ATTACHMENT A

KENWOOD COMMUNITY & SENIOR CENTER ATTACHEMENT A

ADDENDUM #1 – REVISED DRAWINGS

1 TYPICAL UNIVERSAL SINGLE DOOR ROUGH-IN DETAIL
SCALE: NTS

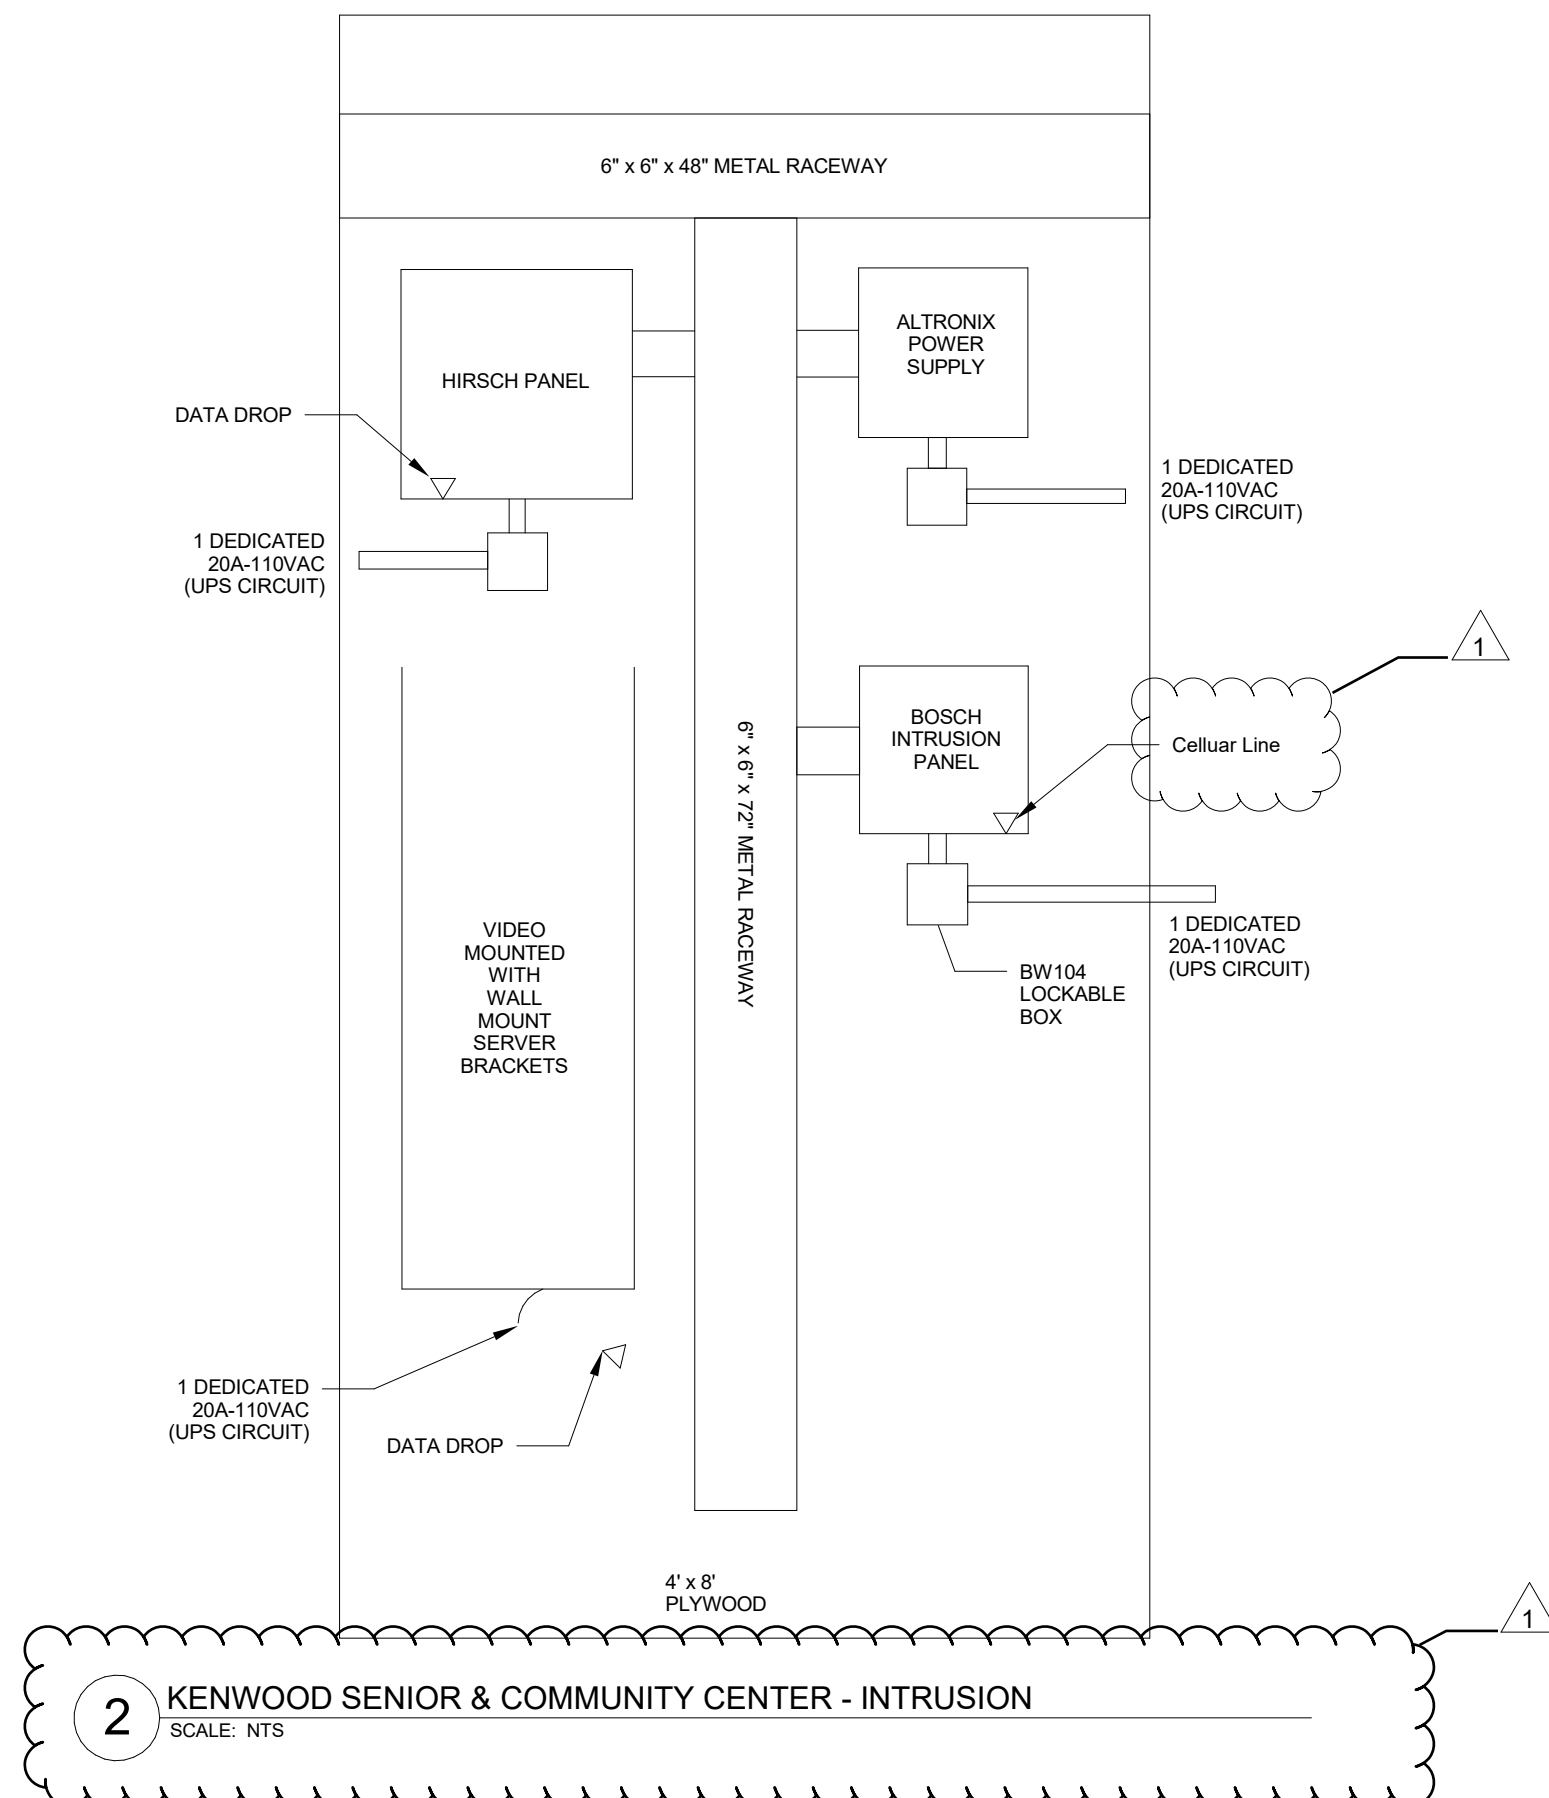
PROJECT MANUAL:**No 1, Tech. Item 1: To the Project Manual, 271500, 2.3.C.7****REVISE** manufacture from; Panduit - CFPL2SY, CFPL4SY, or CFPL6S-2GY to Panduit - Grey – Coordinate exact color with owner.**DRAWINGS:****No 1, Tech. Item 2:** Sheet# T101 – TECHNOLOGY – LEVEL ONE**DELETE** 1 ceiling mounted camera from Room# 101,**No 1, Tech. Item 3:** Sheet# T101 – TECHNOLOGY – LEVEL ONE**ADD** 1 Wall-Mounted Motion Detector to Room# 114**No 1, Tech. Item 4:** Sheet# T101 – TECHNOLOGY – LEVEL ONE**DELETE** 3 Multi-Imager Cameras from Room# 115**DELETE** 1 Wall-Mounted Motion Detector from Room# 115**ADD** 2 Ceiling-Mounted Multi-Imager Cameras to Room# 115**ADD** 1 Ceiling -Mounted Motion Detector to Room# 115**ADD** 2 Network drop locations (4 cables) to Room# 115**No 1, Tech. Item 5:** Sheet# T101 – TECHNOLOGY – LEVEL ONE**RELOCATE** 1 Multi-Imager Cameras in Room# 123.**No 1, Tech. Item 6: DELETE** Sheet# T102 – TECHNOLOGY – LEVEL ONE CEILING PLAN**No 1, Tech. Item 7:** Sheet# T601 – T601 – TECHNOLOGY – SECURITY DETAILS**Revise** Detail # 2**ATTACHMENTS:**
